UNITED STATES PATENT AND TRADEMARK OFFICE

APPLICATION NO.	FILING DATE	FIRST NAMED INVENTOR	ATTORNEY DOCKET NO.	CONFIRMATION NO.
10/619,017	07/14/2003	Stephen C. Thatcher	10,220	8801

Office Action Summary	Application No. 10/619,017	Applicant(s) THATCHER ET AL.	
	Examiner Árpád Fábíán Kovács	Art Unit 3671

1. Restriction to one of the following inventions is required under 35 U.S.C. 121:
 - I. Claims 1-16, 20-28, drawn to a parallelogram suspension system for deck height adjustment, classified in class 56, subclass 15.8.

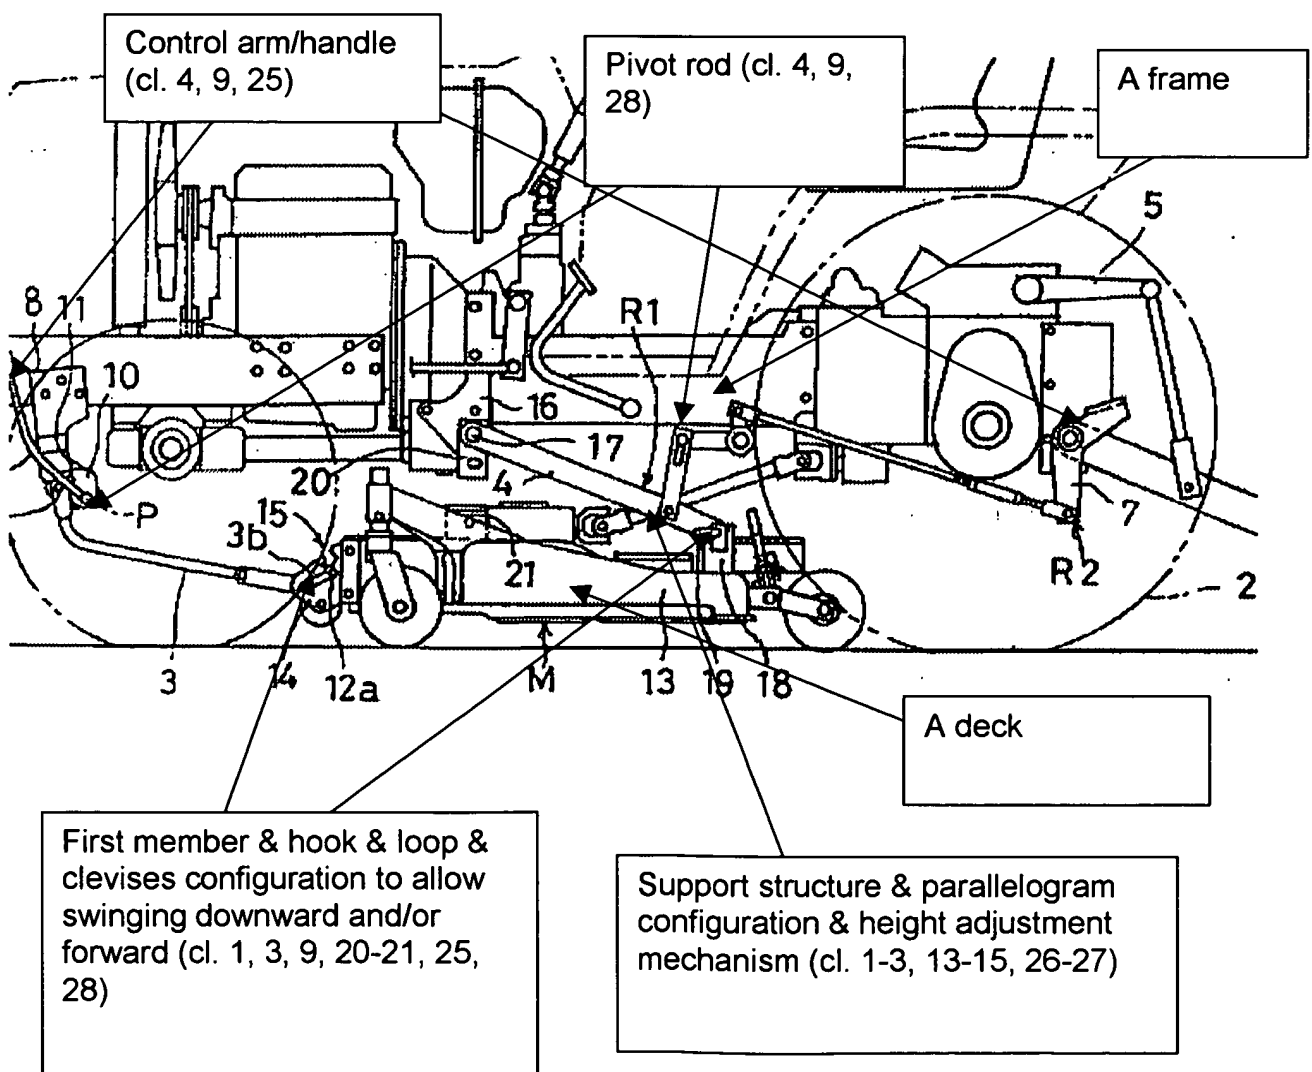
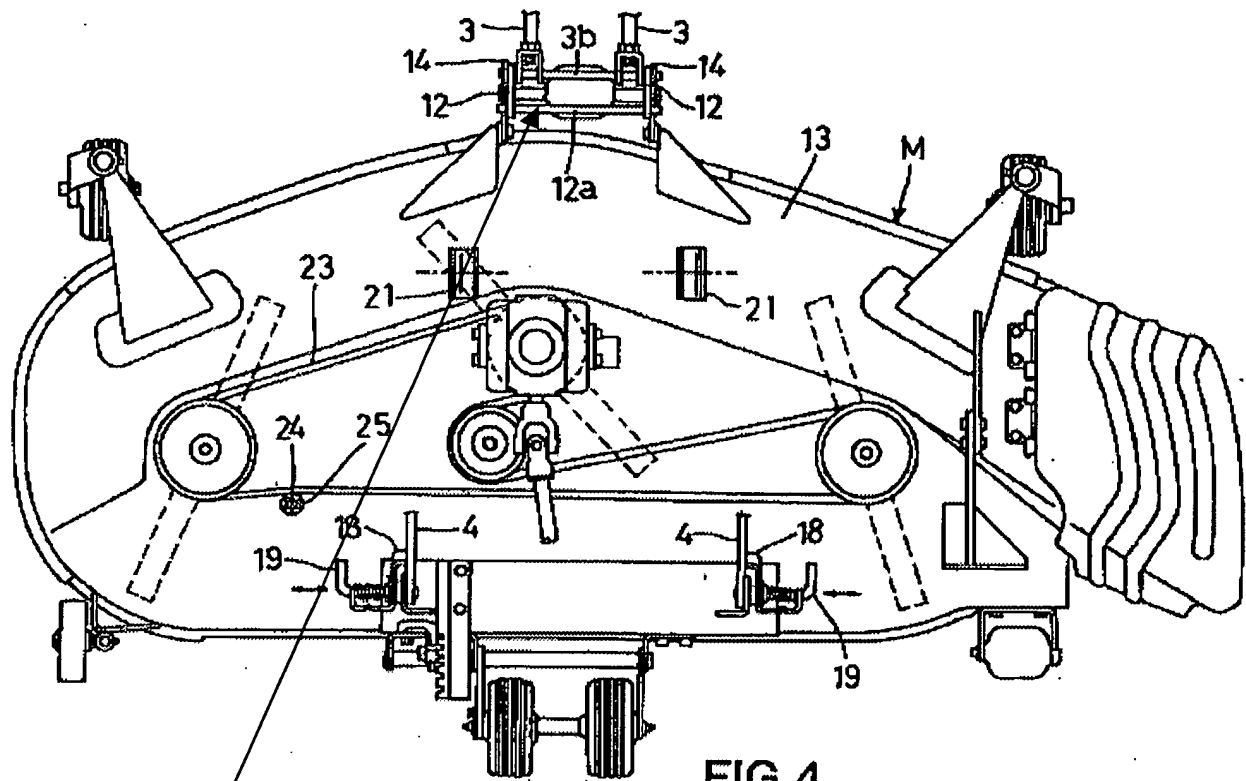
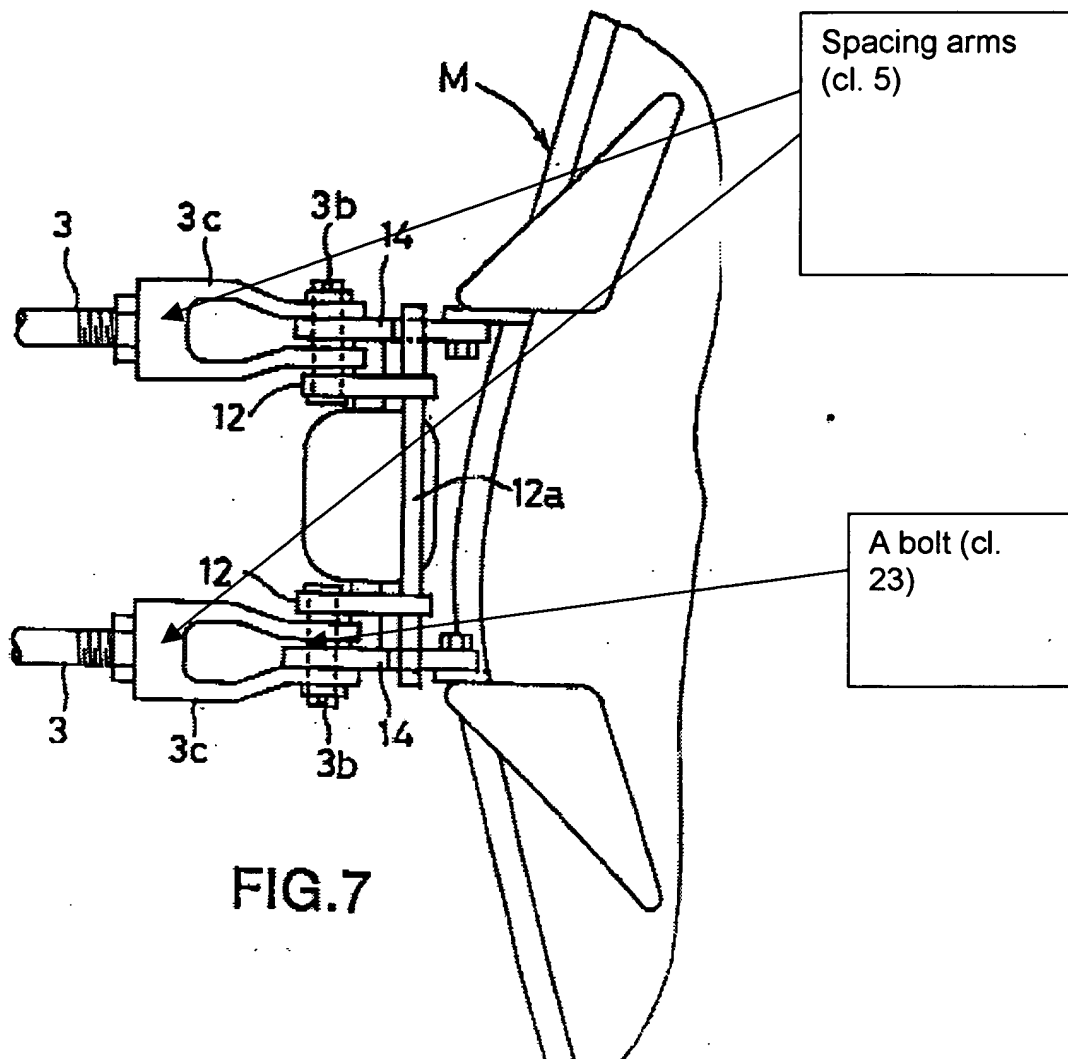
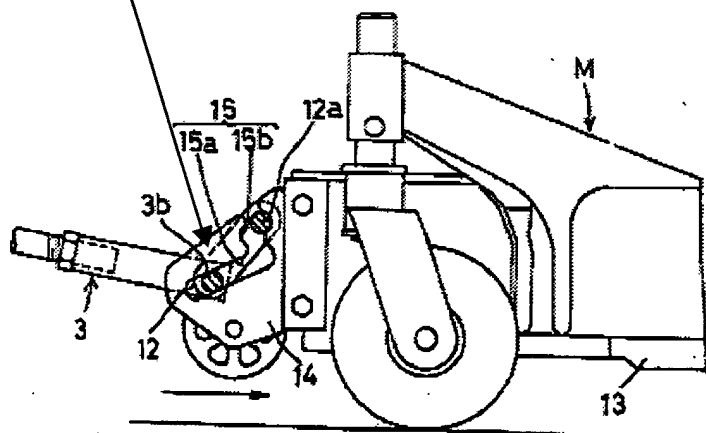
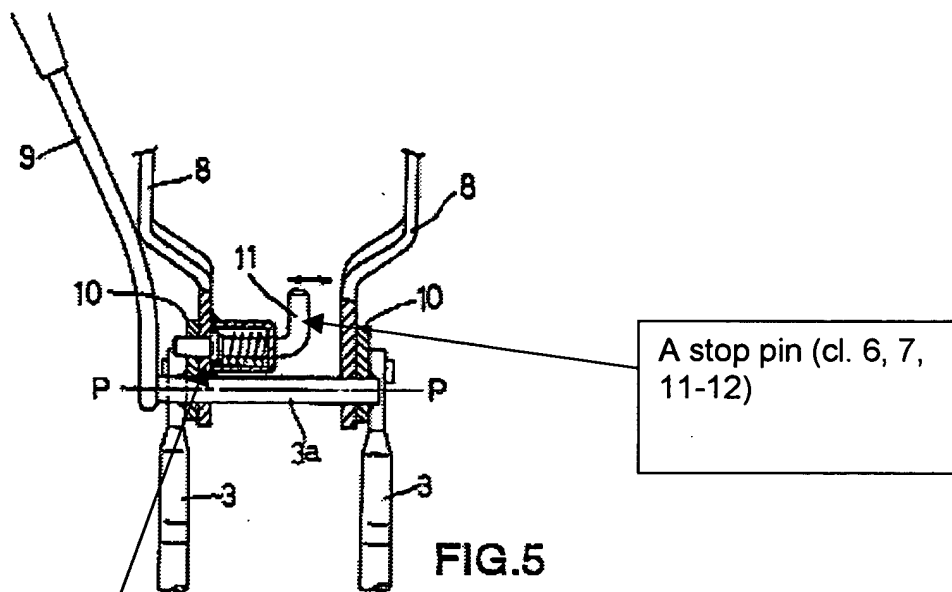
10. Claims 1-16, 20-28 are rejected under 35 U.S.C. 102(b) as being anticipated by Kure et al (5528889).

Kure discloses as best shown in the marked up drawings below for greater clarity:

A pivot rod/bail (cl. 4, 10,
25, 28)
